PLANNING NMA-CHANGE LIST		
ID	Proposed Changes to plans that are 'Non Material'	Reason for 'Amendment'
A	Changes to Common stair towards compliance for general access where a clear landing needs to be provided and to accommodate smoke control. Circulation area and internal doorway to stairs rearranged to adapt corridor aisle. Stairs, structurally stacked for construction leading towards the corridor or lobby next to the stair being provided with a smoke vent and a store area provision on ground level. Rearrangement in plan due to the above visible on the Northwest facade. Window openings, adapted to suit mentioned changes/rearrangement.	Compliance towards Building Regulations, Part-K-Protection from falling, collision and impact and Part-B-Fire safety
B	Changes to Communal lifts and stairs towards compliance for firefighting where a firefighting shaft is required as the building is over 18m and to accommodate smoke control and building services. Circulation area internal doorway to stairs and clear landing for lifts rearranged to adapt corridor aisle. Stairs, structurally stacked for construction leading towards a vertical smoke shaft that opens at roof level with rationalised comm

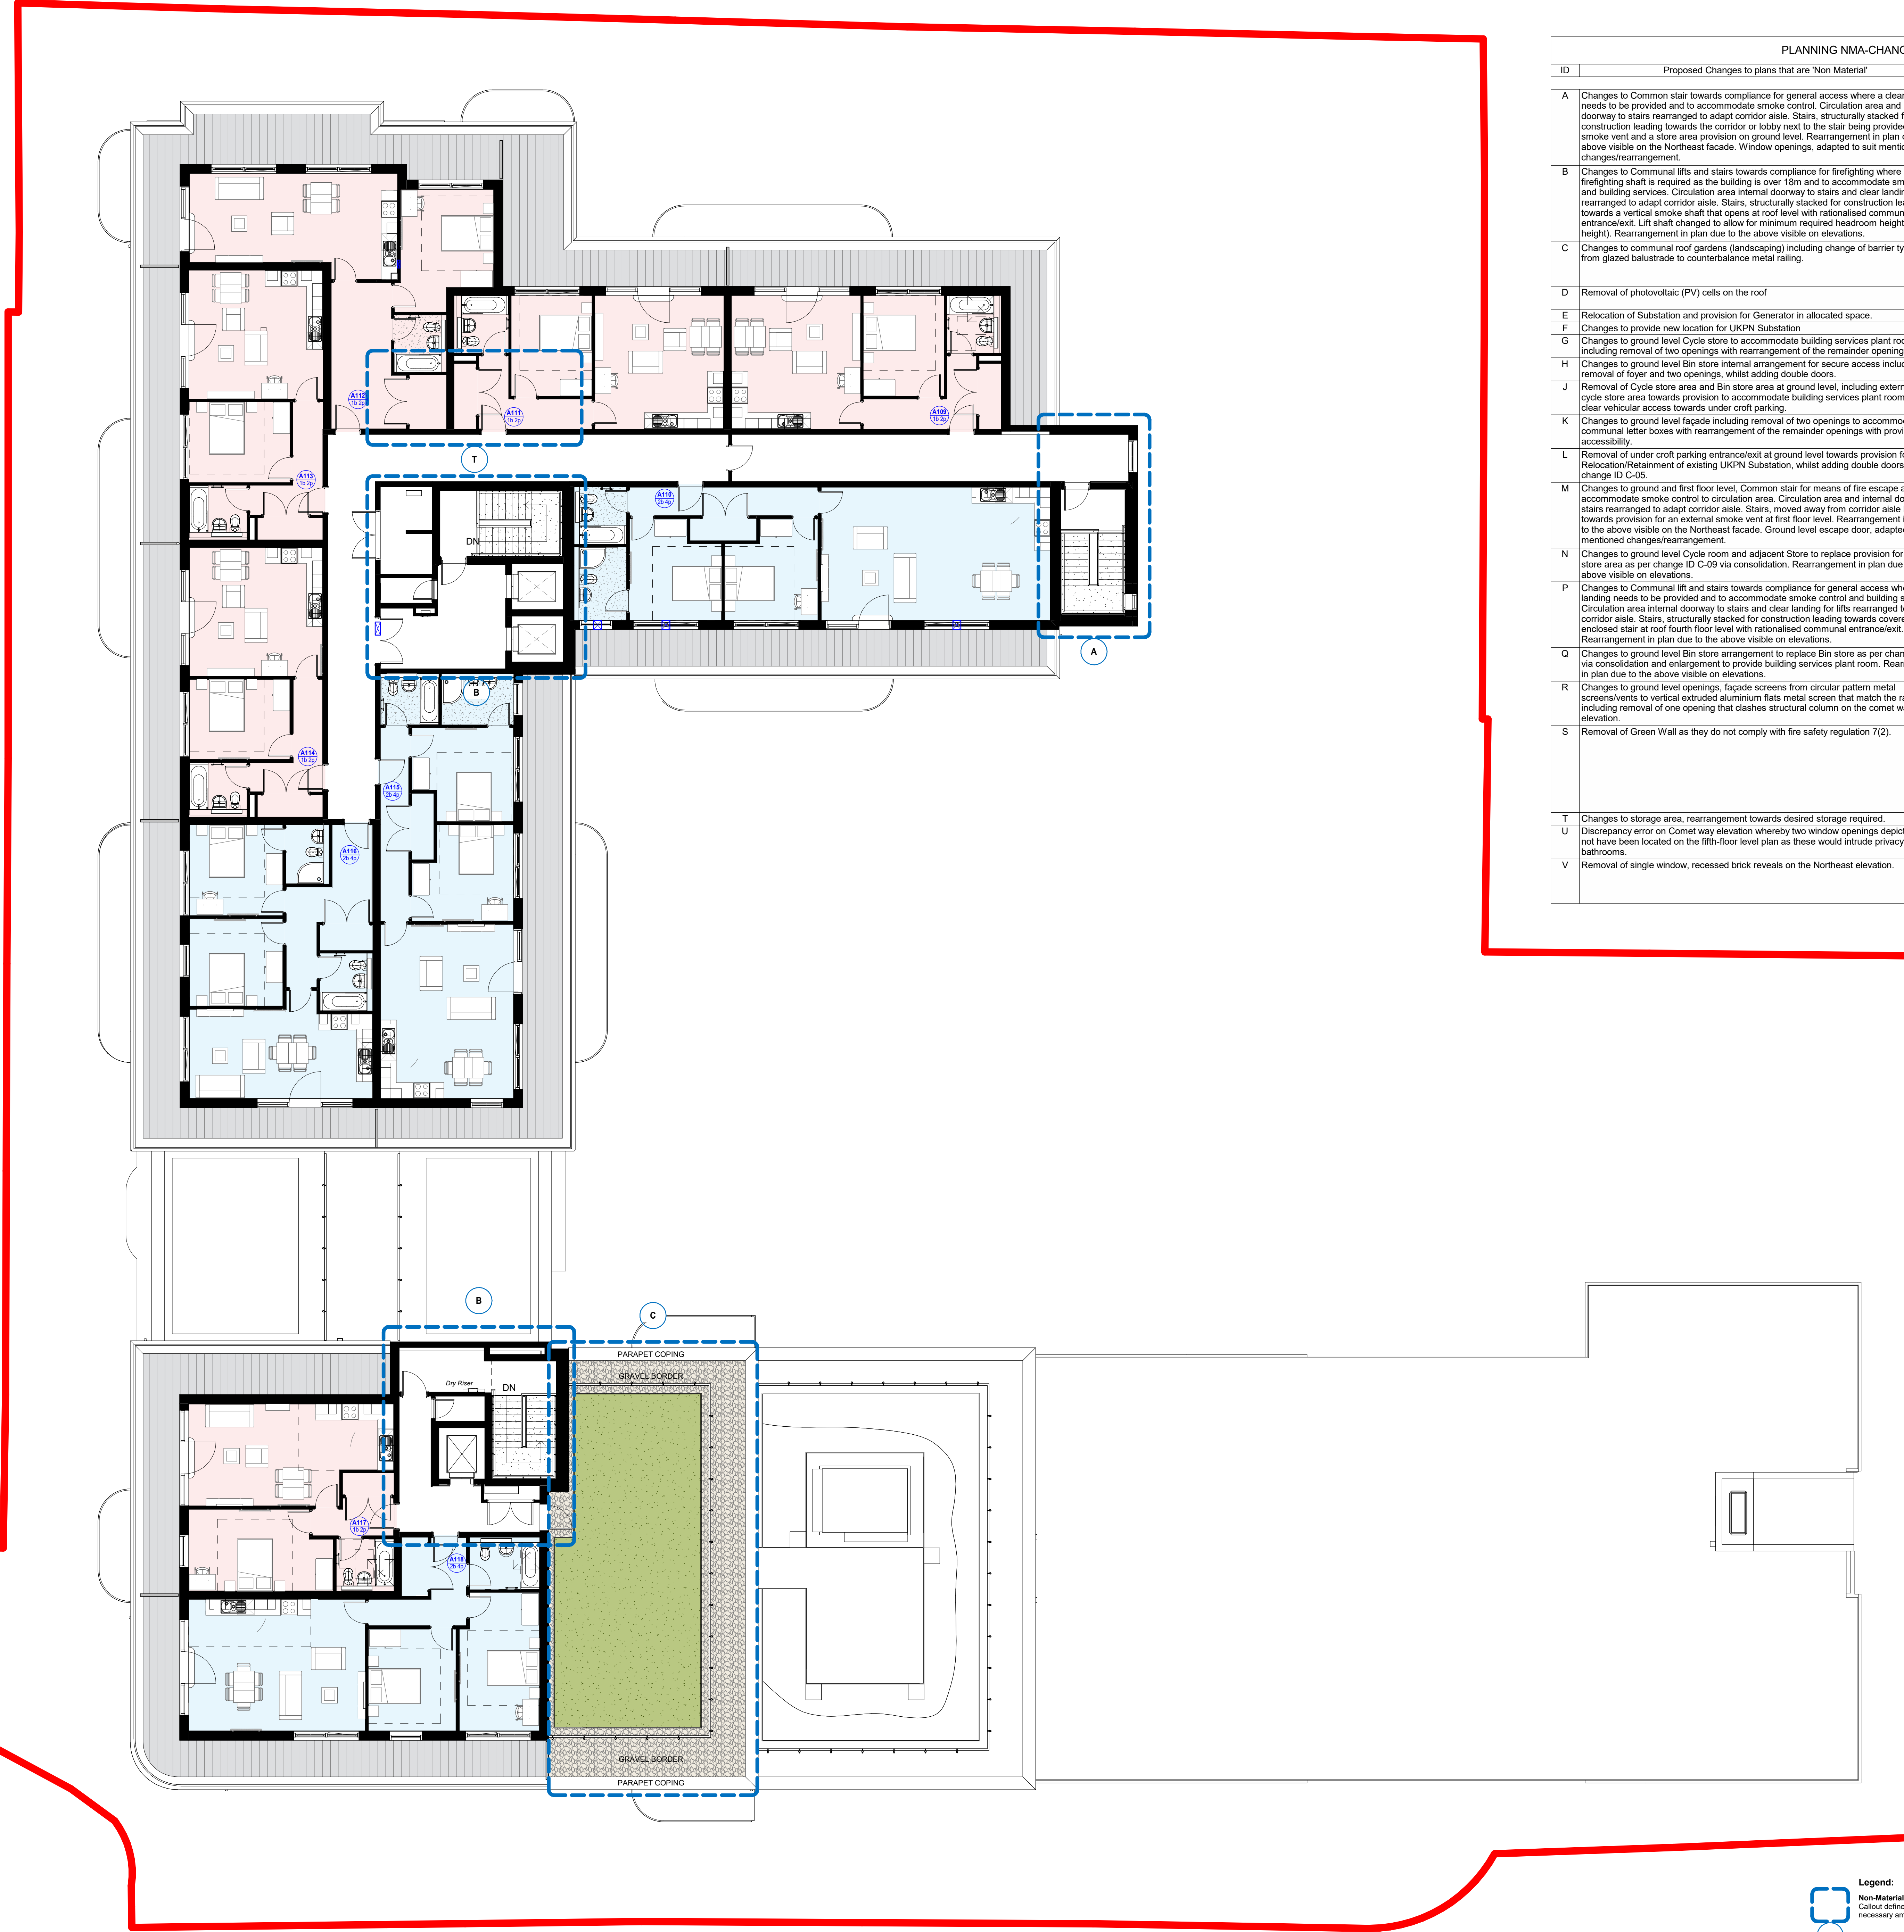
C	Changes to communal roof gardens (landscaping) including change of barrier type (railing) from glazed balustrade to counterbalance metal railing.	To contribute positively towards biodiversity via balance of soft and hard landscaping schemes including provisions for bird and bat boxes, whilst maintaining overall uniformity for railing type.
D	Removal of photovoltaic (PV) cells on the roof	PV was not required as Part L requirement was met using Exhaust Air Heat Pumps.
E	Relocation of Substation and provision for Generator in allocated space.	Provision for separate secluded area for generator
F	Changes to provide new location for UKPN Substation	Provision for future relocation for UKPN Substation
G	Changes to ground level Cycle store to accommodate building services plant rooms including removal of two openings with rearrangement of the remainder openings.	Provision towards Building Services, Secondary LV switch room and Corms room.

H	Changes to ground level Bin store internal arrangement for secure access including removal of foyer and two openings, whilst adding double doors.	Provision towards secure access for Bin store
J	Removal of Cycle store area and Bin store area at ground level, including external door in cycle store area towards provision to accommodate building services plant room including clear vehicular access towards undercroft parking.	Provision towards Building Services, Primary LV switch room and vehicular access towards undercroft parking.
K	Changes to ground level facade including removal of two openings to accommodate communal letter boxes with rearrangement of the remainder openings with provision for accessibility.	Provision towards communal letter boxes
L	Removal of undercroft parking entrance/exit at ground level towards provision for Relocation/Retainment of existing UKPN Substation, whilst adding double doors as per change ID C-05.	Provision towards single point of entry/exit for undercroft parking and towards relocation/retainment of existing UKPN Substation mentioned in change ID-E.

M	Changes to ground and first floor level, Common stair for means of fire escape and to accommodate smoke control to circulation area. Circulation area and internal doorway to stairs rearranged to adapt corridor aisle. Stairs, moved away from corridor aisle leading towards provision for an external smoke vent at first floor level. Rearrangement in plan due to the above visible on the Northeast facade. Ground level escape door, adapted to suit mentioned changes/rearrangement.	Compliance towards Building Regulations, Part-B-Fire safety.
N	Changes to ground level Cycle room and adjacent Store to replace provision for Cycle store area as per change ID C-09 via consolidation. Rearrangement in plan due to the above visible on elevations.	Provision towards replacement of removed cycle store mentioned in change ID-J.
P	Changes to Communal lift and stairs towards compliance for general access where a clear landing needs to be provided and to accommodate smoke control and building services. Circulation area internal doorway to stairs and clear landing for lifts rearranged to adapt corridor aisle. Stairs, structurally stacked for construction leading towards covered and enclosed stair at roof fourth floor level with rationalised communal entrance/exit. Rearrangement in plan due to the above visible on elevations.	Compliance towards Building Regulations, Part-K-Protection from falling, collision and impact, Part-B-Fire safety and Provision for stair enclosed/walkway that is directly covered.

Q	Changes to ground level Bin store arrangement to replace Bin store as per change ID C-09 via consolidation and enlargement to provide building services plant room. Rearrangement in plan due to the above visible on elevations.	Provision towards replacement of removed Bin store mentioned in change ID-J and provision for BCW Tank room.
R	Changes to ground level openings, facade screens from circular pattern metal screens/vents to vertical extruded aluminium flats metal screen that match the railing type, including removal of one opening that clashes structural column on the comet way elevation.	To maintaining overall architectural uniformity and structural framing.
S	Removal of Green Wall as they do not comply with fire safety regulation 7(2).	Regulation 7(2), requires all residential blocks with top storey heights over 18m to have all materials which become part of an external wall or specified attachment (e.g., balconies) to achieve class A2-s1, d0 or class A1, except for materials which are exempt as per regulation 7(3). Additionally, membranes used as part of external wall construction above ground should achieve a minimum of class B-s3, d0.

T	Changes to storage area, rearrangement towards desired storage required.	Provision towards desired storage required.
U	Discrepancy error on Comet way elevation whereby two window openings depicted would not have been located on the fifth-floor level plan as these would intrude privacy for the bedrooms.	Discrepancy error
V	Removal of single window, recessed brick reveals on the Northeast elevation.	The recessed brick reveals is between two windows mostly on all elevations, whilst single windows mostly do not have such a detail. To maintain architectural uniformity, detail removed.
